# TWIN CREEK WATER SUPPLY CORPORATION

## ADDENDA #11 TO TARIFF

Section E. 28. Member's Responsibility e.) (page 29):

Outside of TCWSC Meter Box to Hand Valve

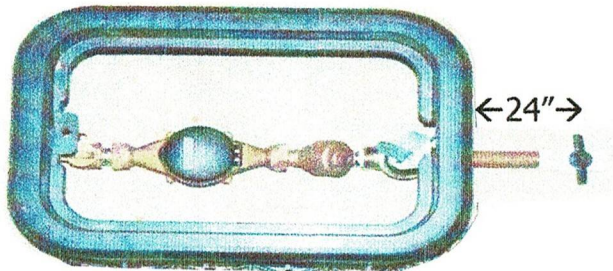
The Corporation shall require each Member to have a cut-off valve on the Members' side of the meter box as close as physically possible to the meter box, but no closer than 24" from the meter box for the purposes of isolating the Member's service pipeline and plumbing facilities from the Corporation's water pressure. As a condition of receiving water service, all new accounts must have this cut-off valve installed before the Customer Service Inspection (CSI) is performed and passed or water service will not be activated. The above is also required anytime a CSI is triggered for the approved reasons. **The Member's use of the Corporation's curb stop or other similar valve for such purposes is prohibited. Any damage to the Corporation's equipment shall be subject to service charges**
